MASTER DEVELOPMENT PLAN FOR ALAMEDA BUSINESS PARK

REVISED MARCH 3, 1999
REVISED JULY 2, 1999
REVISED 7/12/00

LANDSCAPING DEVELOPMENT REQUIREMENTS FOR ALAMEDA BUSINESS PARK

To: Zoning Enforcement/ Plan Check Desk, Planning Dept.
From: Marcia A. Pincus, Environmental Health Department
Subject: Alameda Business Park

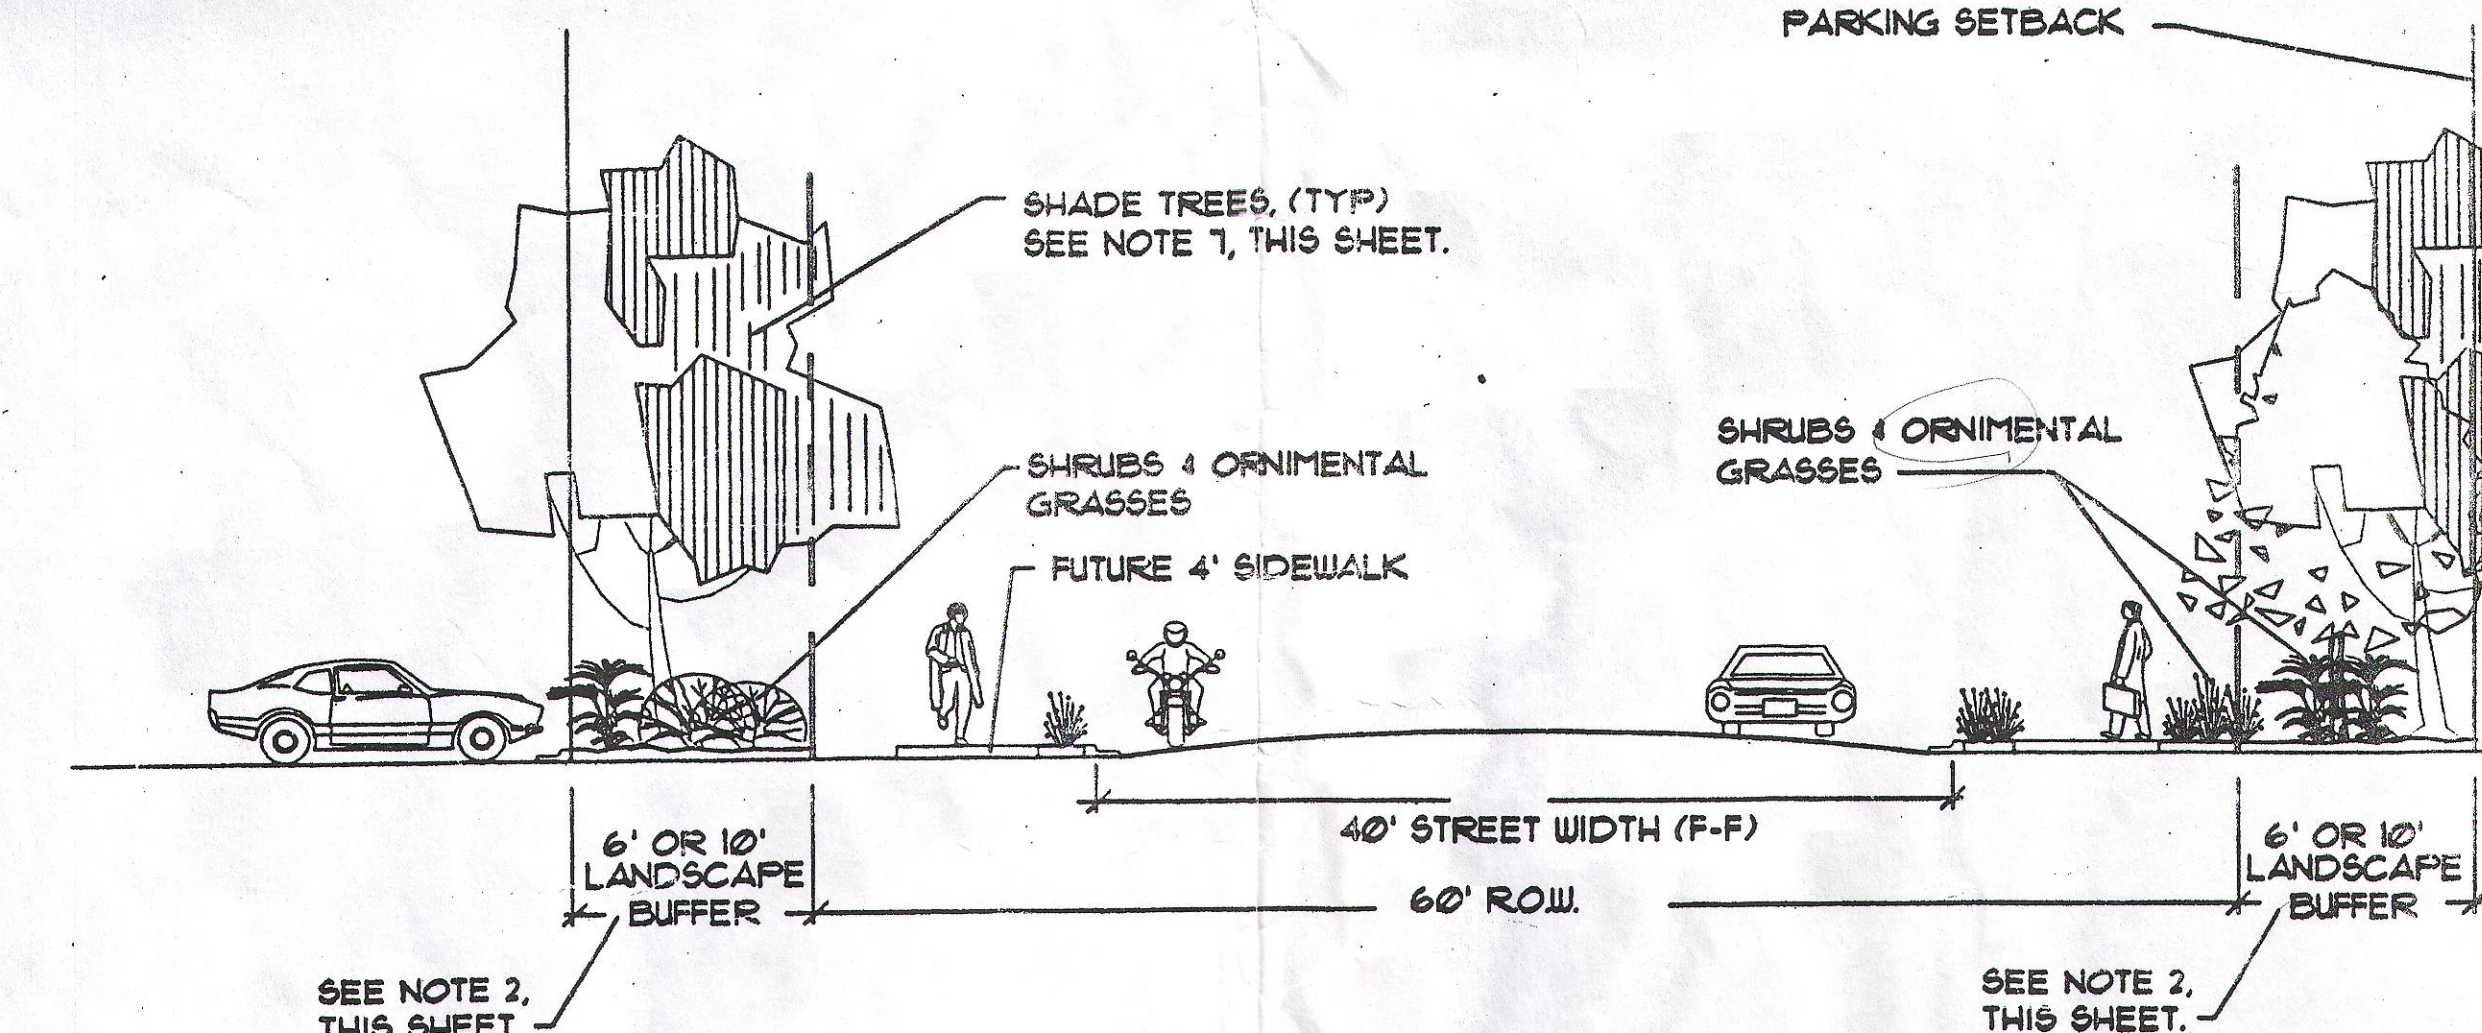
~~2) IF NOT REQUIRED BY COA ZONING ENFORCEMENT STAFF THIS BUFFER SHALL NOT BE REQUIRED.~~

~~Fencing and landscaping along Edith Blvd. shall be maintained in perpetuity.~~
